# GERMANTOWN MULTIMODAL IMPROVEMENTS STUDY: ALTERNATIVES ANALYSIS

MCPB

Item No. 8

2/29/2024

Figure 6: Wisteria Alternative 1. Western Terminus

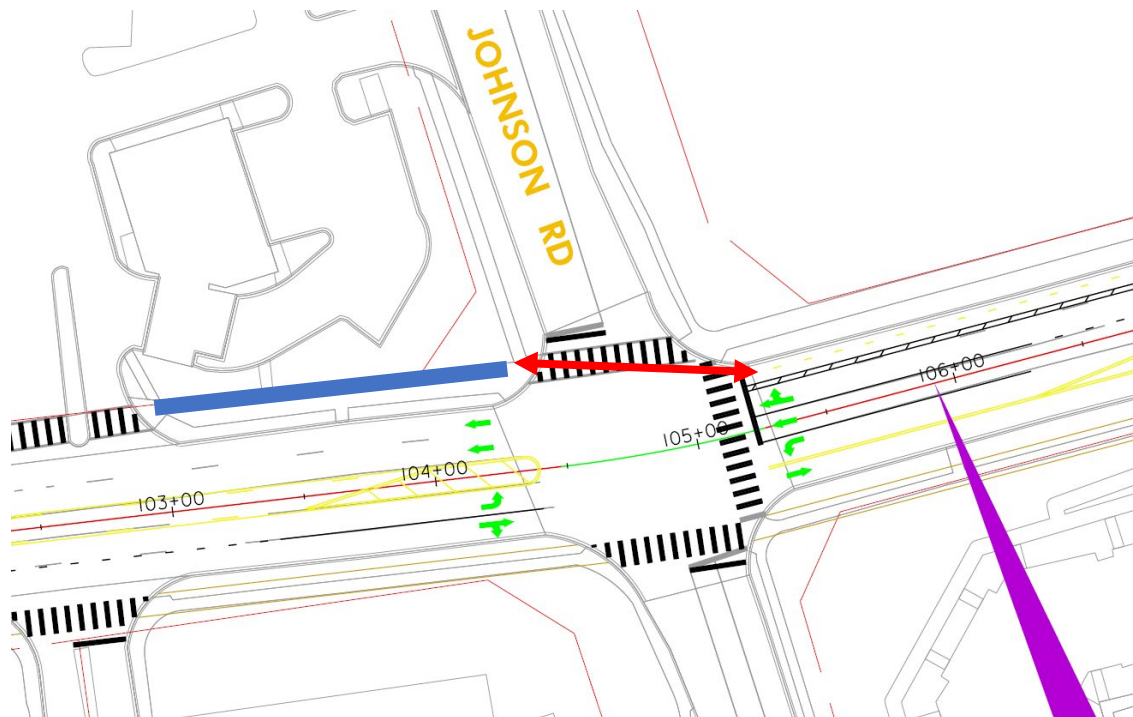
Wisteria Drive Alternative 1 is a short-term, interim treatment that includes eight-foot separated bike lanes and a three-foot buffer and occasional on-street parking, while Alternative 2a provides a twelve-foot separated bike lane and a six-foot buffer. The Alternative 1 buffer does not achieve the master plan minimum width.

Figure 13: Alternative 2. Middlebrook Road Corridor (Looking East)

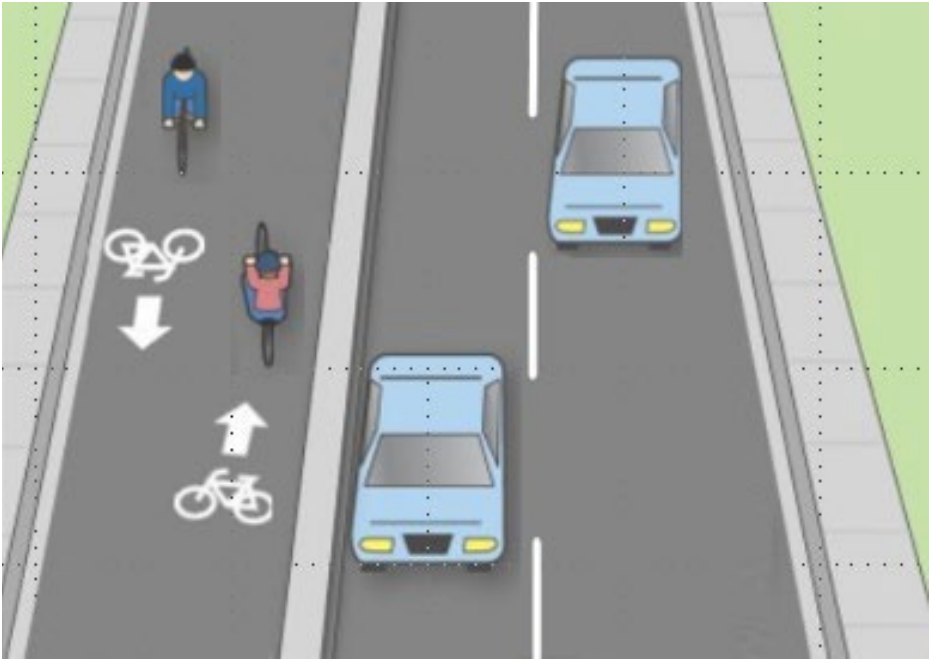
**Alternative 2 Modification: Upgrade the existing separated bike lanes on the south side of Middlebrook Road as part of Alternative 2.**

The existing separated bike lanes on the south side of Middlebrook Road are separated from motor vehicle traffic using pavement markings, flex posts, and concrete parking stops, as shown in Figure 20. This is the intended configuration for the Middlebrook Road Alternative 1. When MCDOT implements Middlebrook Road Alternative 2 on the north side of the road with raised medians as illustrated in Figure 13, it should also upgrade the south side buffer to a concrete median.

Figure 14: Western Terminus of Alternative 2a

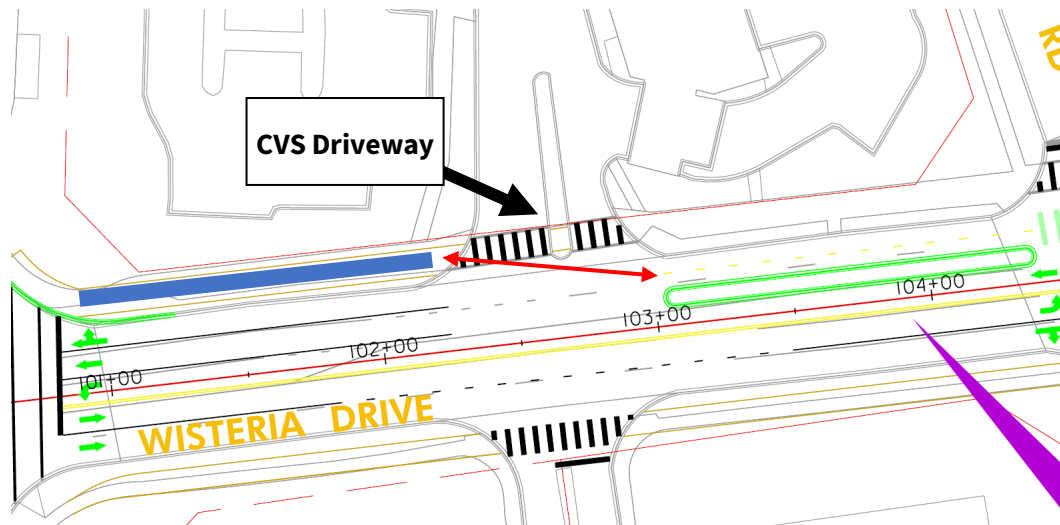
Two-way separated bike lanes are the master-planned bike facility for the north side of Wisteria Drive. Separated bike lanes are the default bikeway type in downtowns and town centers because in locations where more pedestrians and bicyclists are expected, separating these modes reduces conflicts. The project's location in Germantown Town Center and adjacent to Seneca Valley High School indicates that there will likely be significant pedestrian and bicycle activity. Modal separation will make pedestrians and bicyclists more comfortable in this area, and more likely to use the bicycling facilities. At the same time, Alternative 2a does not extend to the Germantown Road intersection. It stops at the CVS driveway as shown in Figure 14.

Ostensibly, bicyclists are intended to transition to and from the sidepath (identified in blue above) across the CVS entrance as they travel to or from Germantown Road and the larger Germantown area. This is unacceptable, and worse than transitioning the separated bike lanes to the sidepath at a signalized intersection with Walter Johnson Road, as proposed in the short-term Alternative 1, shown in Figure 15. A transition from an on-road bikeway to an off-road bikeway at the unsignalized CVS driveway will likely create right-of-way and visibility conflicts.

Figure 15: Northern Terminus of Alternative 1

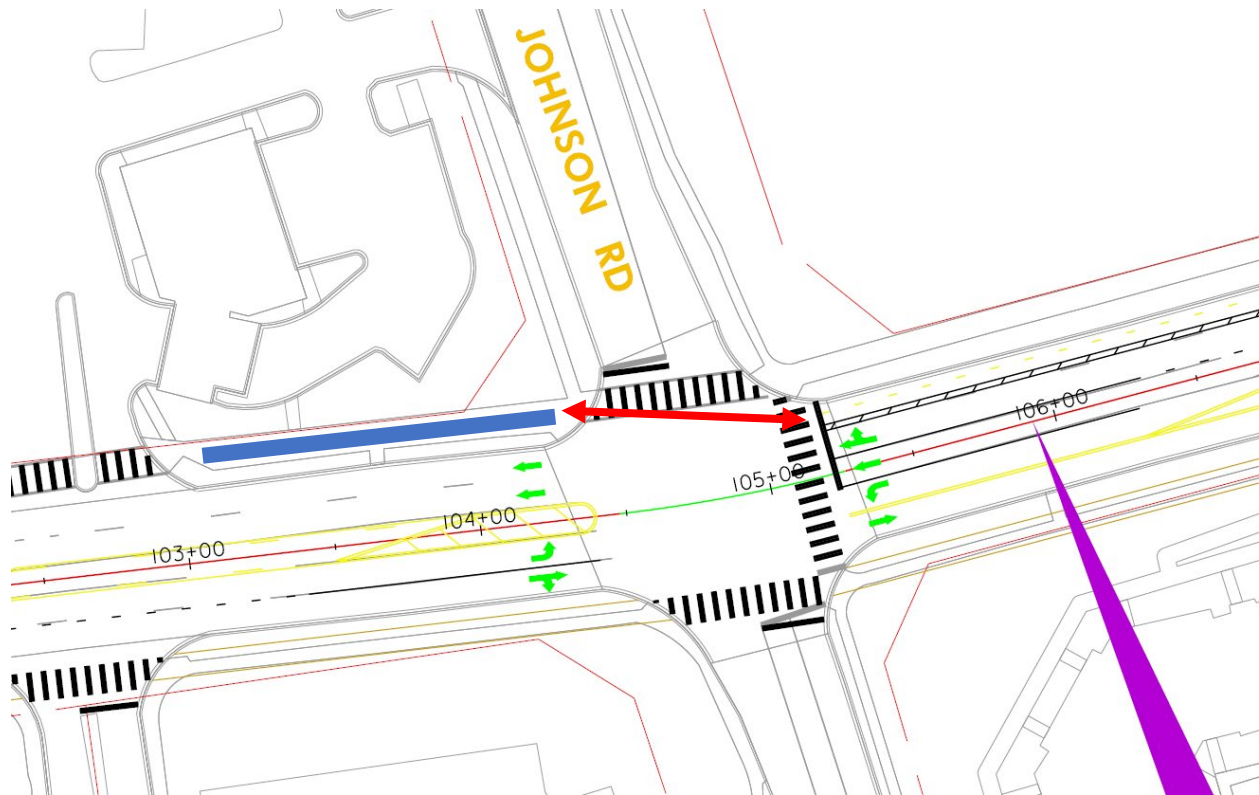
High-quality protected intersection design includes the following elements shown in Figure 15 and discussed in detail in Montgomery Planning’s Protected Intersection Checklist, which was developed in collaboration with MCDOT (*Attachment D*):

- 1) A *Corner Island* to physically separate the bikeway up to the intersection crossing point where potential conflicts with turning motor vehicles can be more easily controlled.
- 2) *Bicycle Queuing Space* to provide a waiting area for stopped bicyclists that is fully within the view of motorists waiting at the stop bar.
- 3) The *Clear Distance* maintains the necessary sight lines between motorists, bicyclists, and pedestrians to stop (or yield) as appropriate.

Figure 16: Western Terminus of Alternative 2a

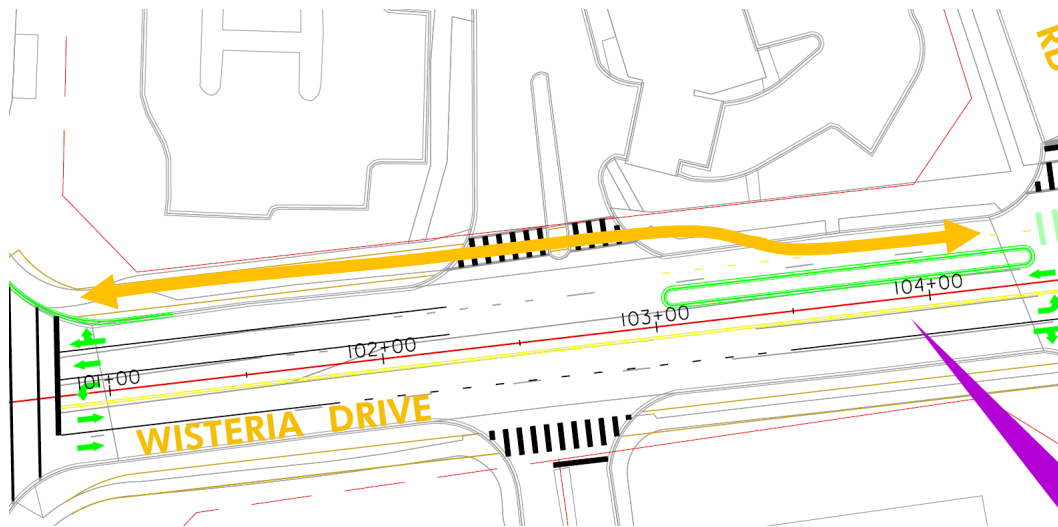
**Alternative 2a Modifications: Transition the on-road separated bike lanes to off-road separated bike lanes just east of the CVS driveway and continue the off-road separated bike lanes to Germantown Road.**

The current Alternative 2a design does not include a direct, safe connection between the CVS driveway and Germantown Road. This connection is essential for the buildout of a low-stress bicycling network in the Germantown area.

To address this concern, the separated bike lanes should transition to outside the roadway curb east of the CVS driveway as illustrated by the orange line in Figure 16. Instead of providing a 14-foot-wide sidepath at this location as described in Alternative 2b, the 14-foot space could be divided into 8-foot-wide separated bike lanes and a six-foot-wide sidewalk. This is shown in Figure 17 with the bikeway (orange arrow) adjacent to the sidewalk (blue arrow). This change would likely require additional right-of-way and result in utility impacts, but would create a high-quality permanent facility.

Figure 18: Middlebrook Bikeway Concepts Approaching Germantown Road

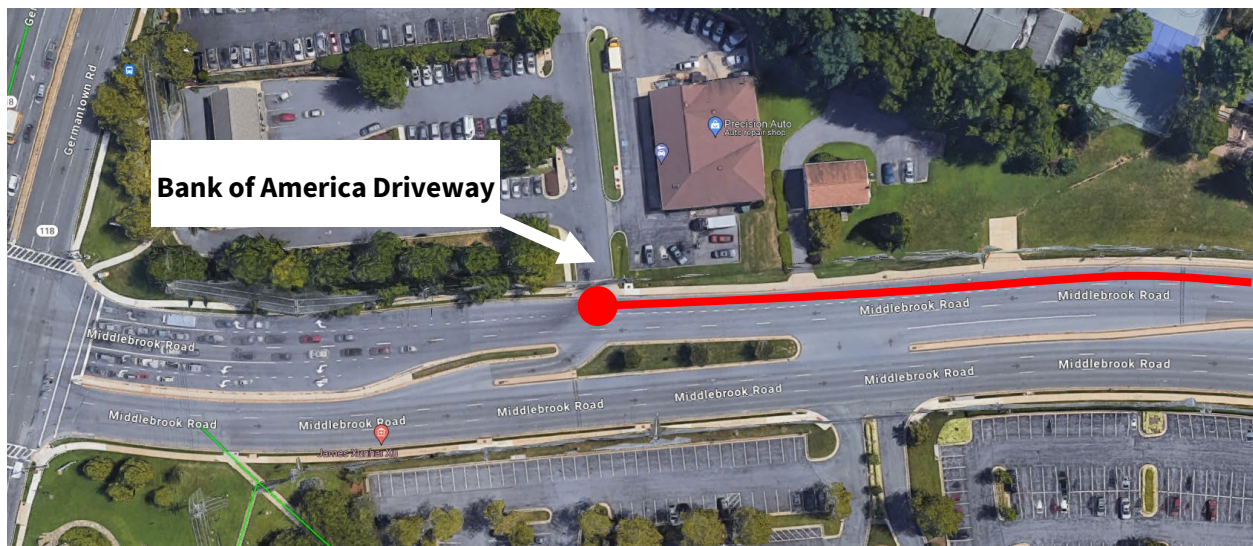
**Alternative 1 and Alternative 2 Modifications: Extend the separated bike lanes from the Bank of America driveway to Germantown Road.**

MCDOT materials do not include corridor drawings for the Middlebrook Road concepts. However, their project description makes clear that in both Middlebrook Road alternatives the bikeway ends at the entrance to the Bank of America property (as illustrated by the red line in Figure 18). This is problematic because bicyclists will be required to travel along a five-foot sidewalk and then transition

to/from an on-street separated bike lane across a heavily used, but unsignalized, commercial driveway to continue biking. Bicycling along the sidewalk creates conflicts with pedestrians, and crossing the unsignalized driveway creates conflicts with motor vehicles – neither support a low-stress experience.

Traffic analysis for scenarios where the Middlebrook Road alternatives were extended to Germantown Road indicate significant increases in westbound peak hour delay. However, as design progresses, the separated bike lanes should be extended to Germantown Road to allow bicyclists to safely travel throughout the Germantown area.

If extending the bikeway to the intersection within the existing roadway is not feasible, shifting the bikeway behind the curb west of the Bank of America driveway should be explored, even if there are steep slopes, utility impacts, or other issues. As a last resort, it may make sense to instead transition the on-street separated bike lane onto a rebuilt, wider sidepath that connects to the Germantown Road intersection starting at Crystal Rock Drive, as shown in Figure 19. The bikeway is not a relevant low-stress option for most potential bicyclists if it does not connect directly to the Germantown Road intersection.
